F.1 953 Balmoral Road - Rezoning Application No. 00598 & Development Permit with Variances Application No. 000506 (North Park)

Subject: Rezoning Application No. 00598 for 953 Balmoral Road

Subject: Development Permit with Variances Application No. 000506 for 953 Balmoral Road

SITE PLAN & ROOF PLAN | APARTMENTS @ 953 BALLMORAL | SCHEMATIC DESIGN FOR DEVELOPMENT PERMIT & REZONING APPLICATION | JANUARY '16 2018 | SCALE 1:100

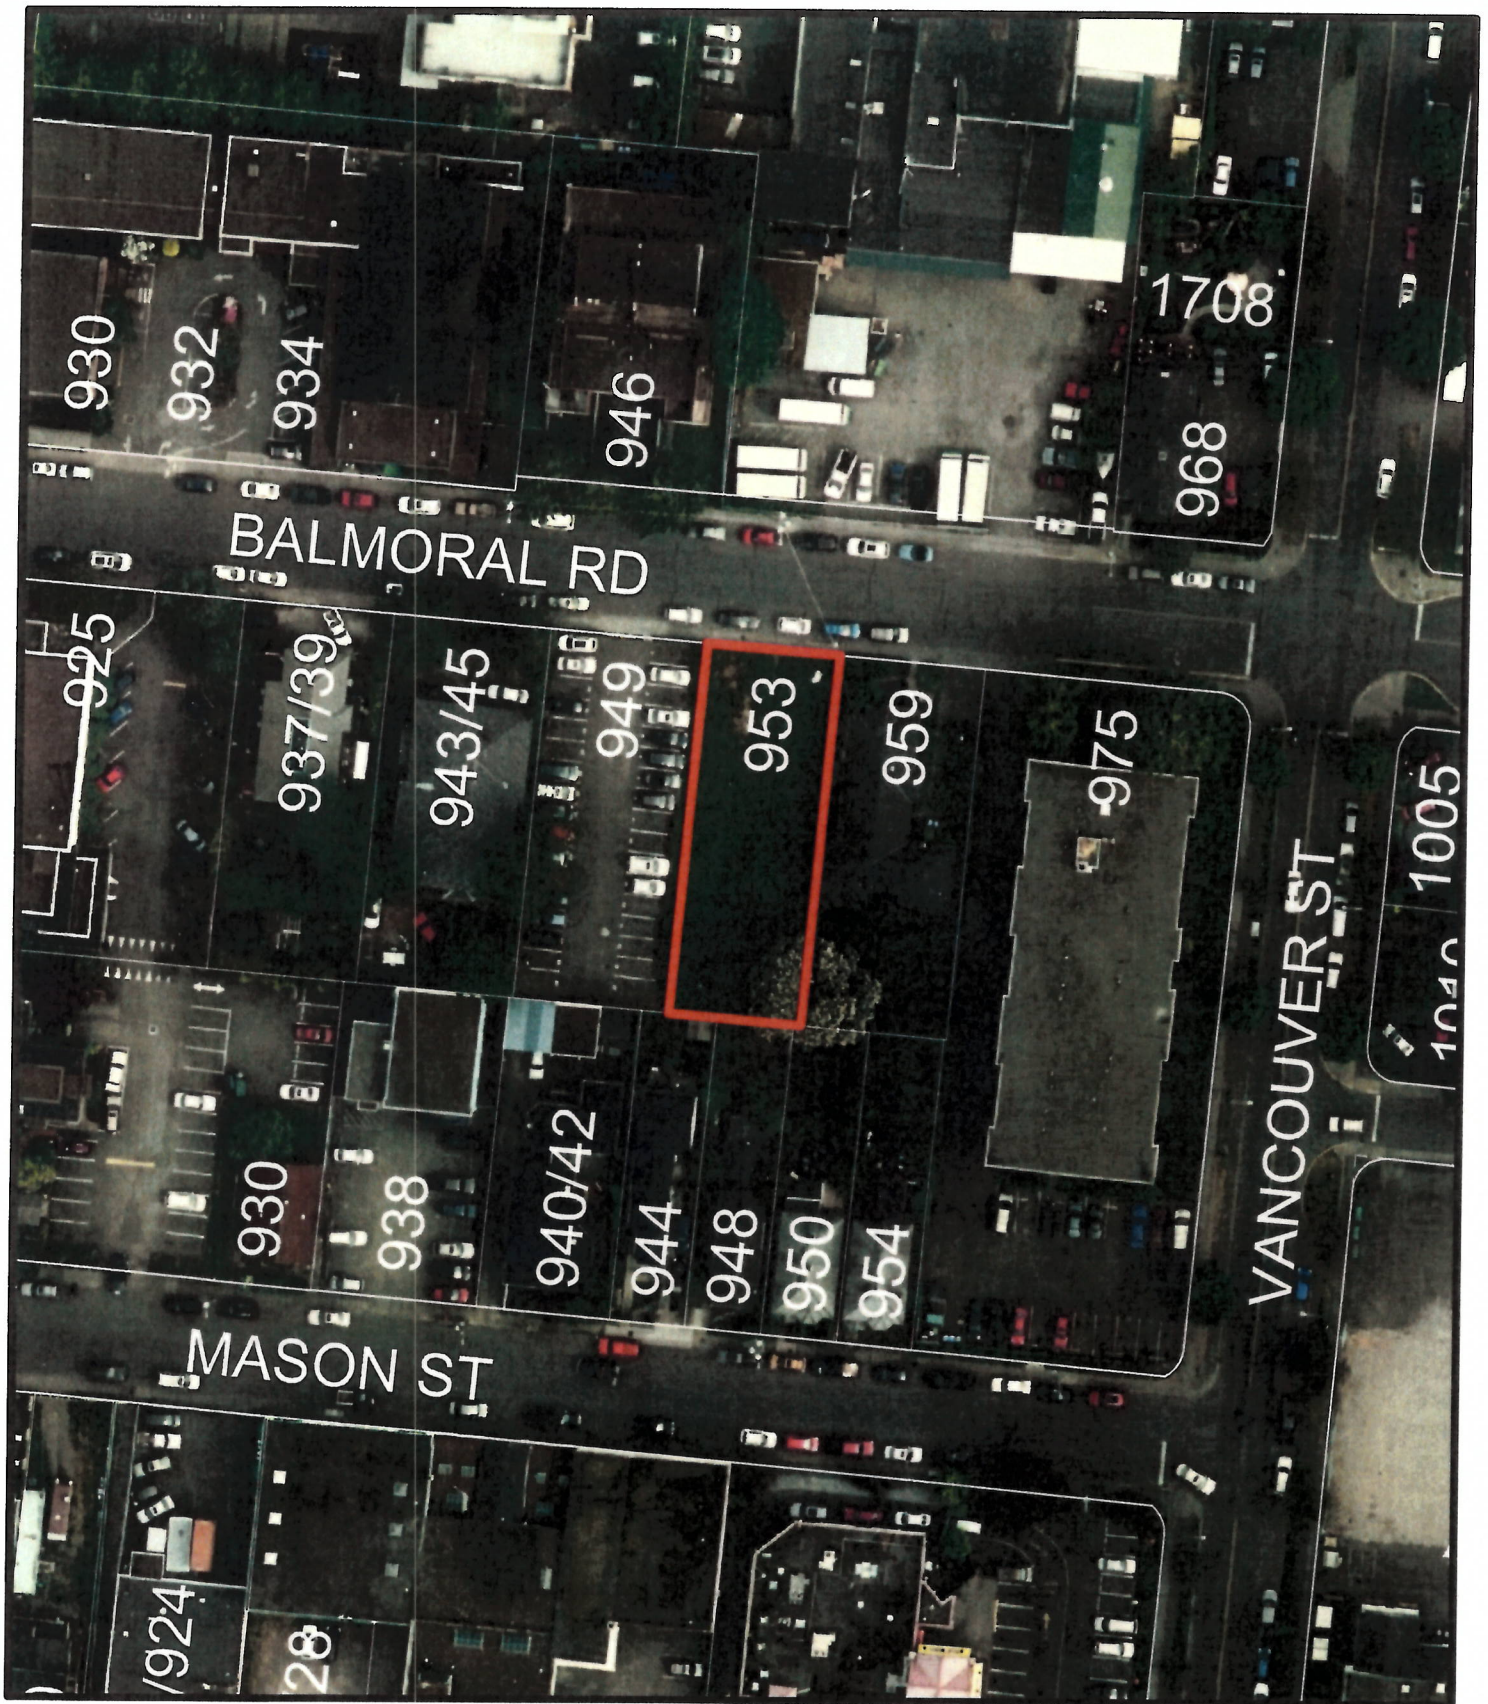
A Statutory Right-of-Way (SRW) of 1.22m is required on Balmoral Road in order to achieve the standard width of a secondary collector street of 20.0m in the Highway Access Bylaw. The applicant will provide the SRW and has shown it on the site plan.

Proposed landscape plan

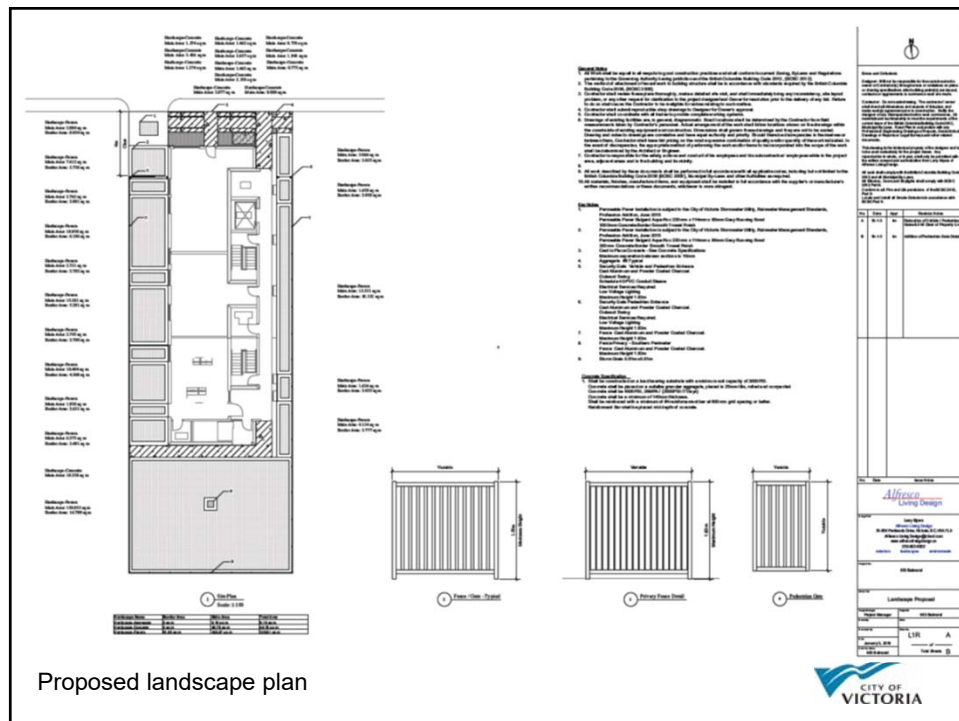
4. Revise the landscape plan to indicate floating pavement where the proposed parking spaces overlap with the tree's critical root zone in accordance with the arborist report prepared by Talbot Mackenzie & Associates.
5. The Development Permit lapsing two years from the date of this resolution."
